### Domain Highways Planning Study

Thank you for the opportunity to comment on the Domain Highways Planning Study.

#### **Brooker Highway**

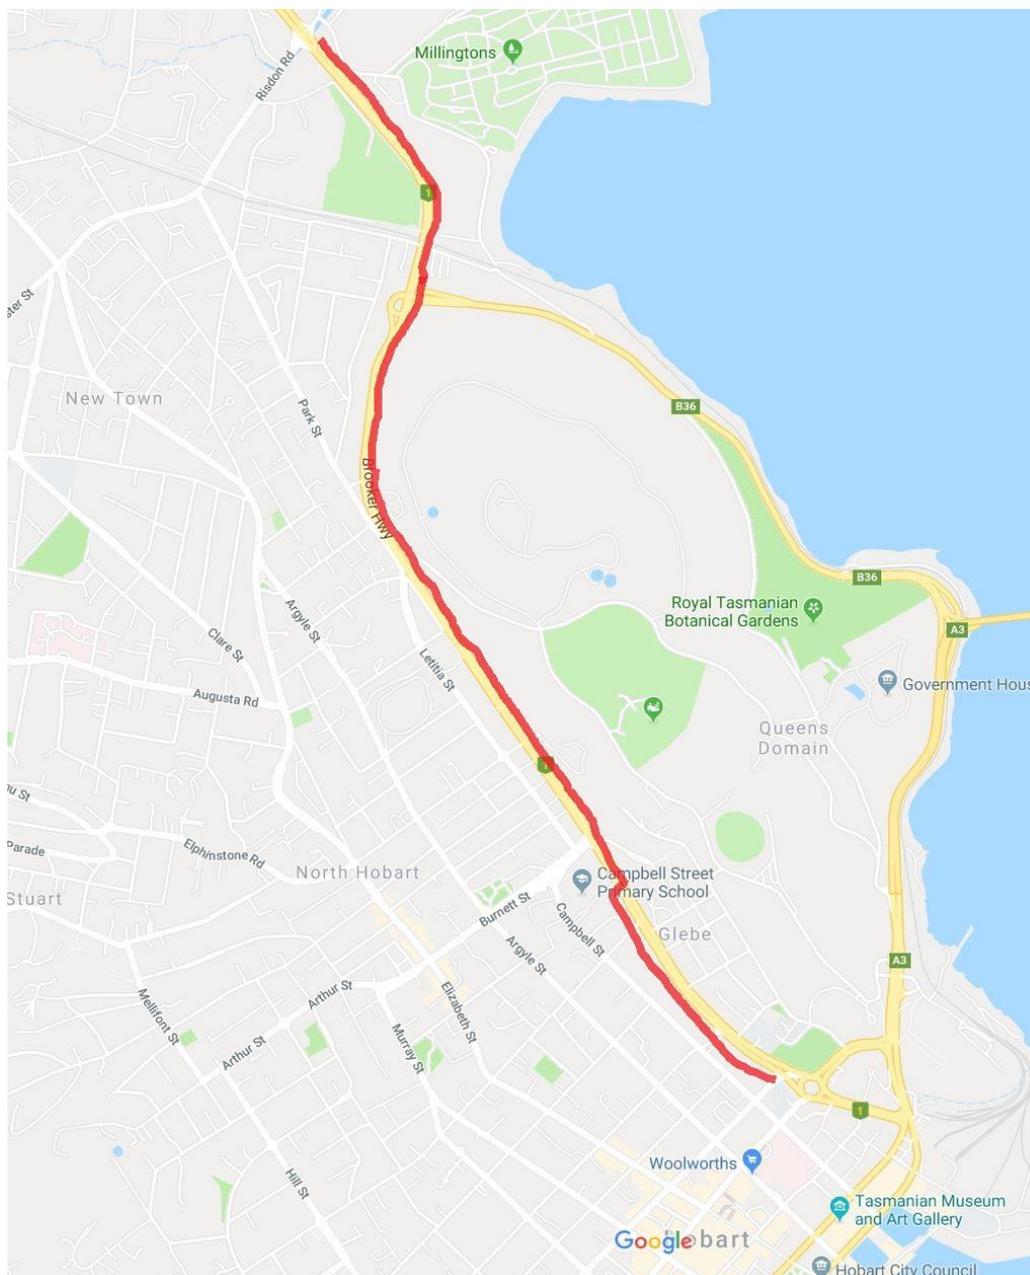
There is the potential to run an off-road path along the Highway from Risdon road using the existing footpath and informal path on the river-side and involving one crossing across the Highway to the city-side. This would involve some engineering works, including cutting into the side of The Domain for a short section, and a pinch point where there is little space to widen the footpath under the Domain Highway overpass. However, the overpass may be re-imagined, and this would also provide the opportunity to allow more space for a path.

There is currently a pedestrian overpass at the point where the path would need to cross the highway, but it would need some work to improve the angles of the on-ramps to make it more suitable for bikes.

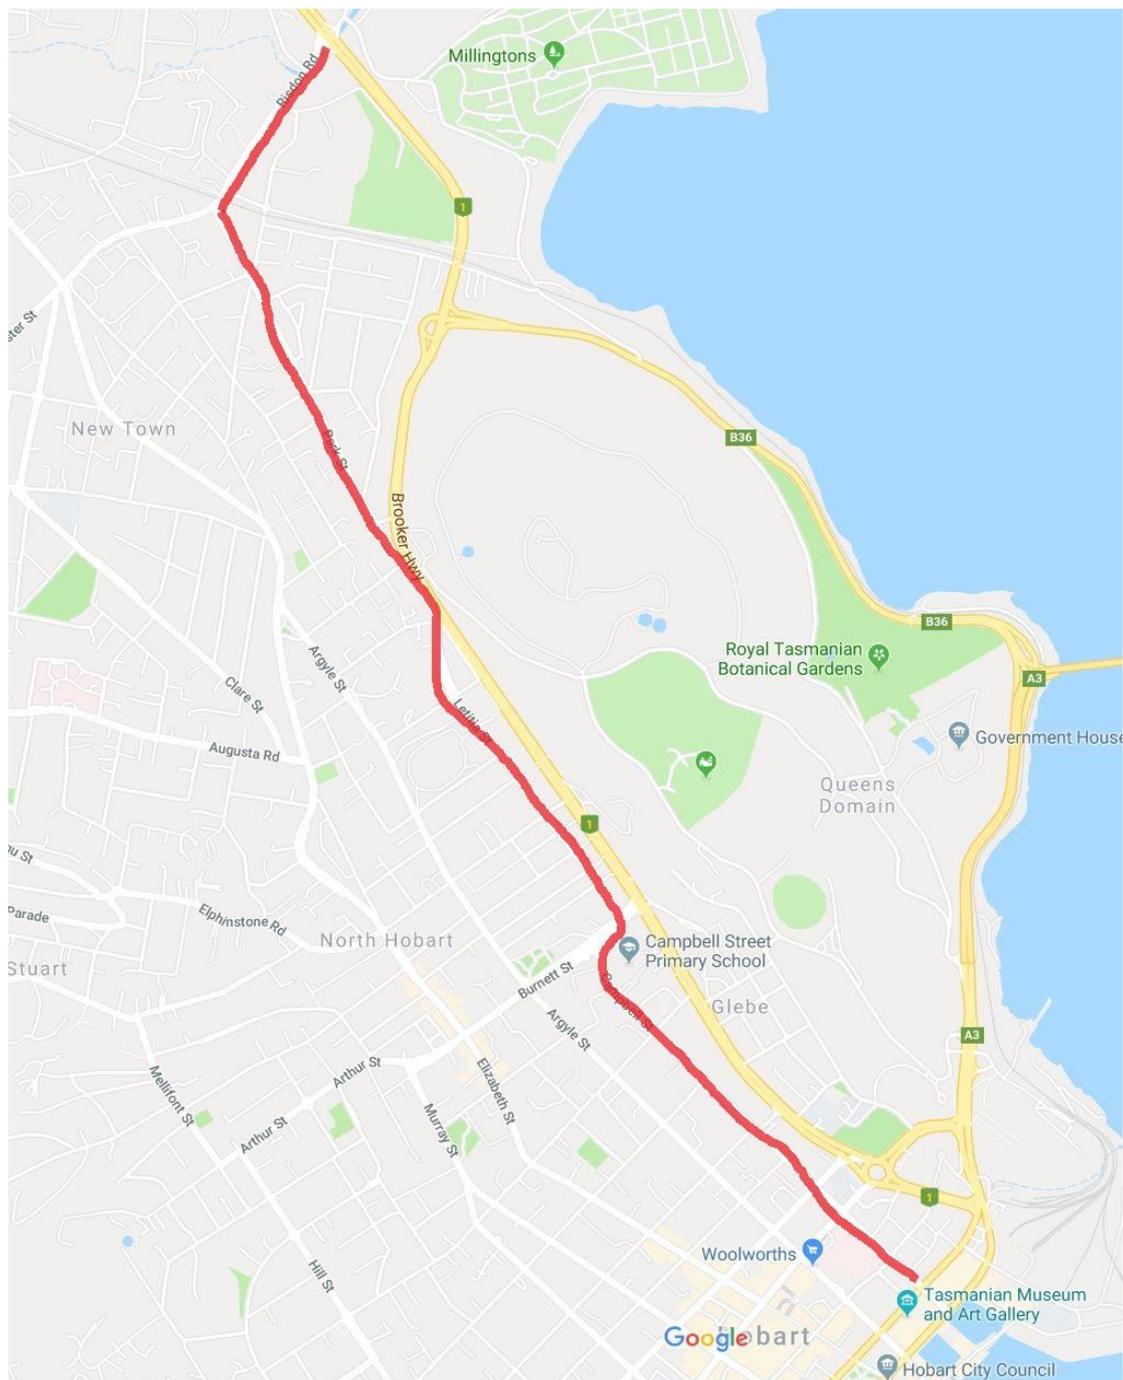
The question is whether it's more desirable to put a path along the Highway or run an all-abilities cycling route down Park, Letitia and Campbell streets. If the state government was willing to work with Hobart Council to help fund the infrastructure, that route may be more suitable, and riders could be directed by signage away from the Highway. It would involve removing some parking along Risdon Rd and creating a raised kerb cycleway alongside the footpath, lowering the speed limit on Park St to 30km/h and designating it a bicycle route, then building a separated cycleway along Letitia St, and a crossing across Burnett Street that connects to a separated cycleway on Campbell St.
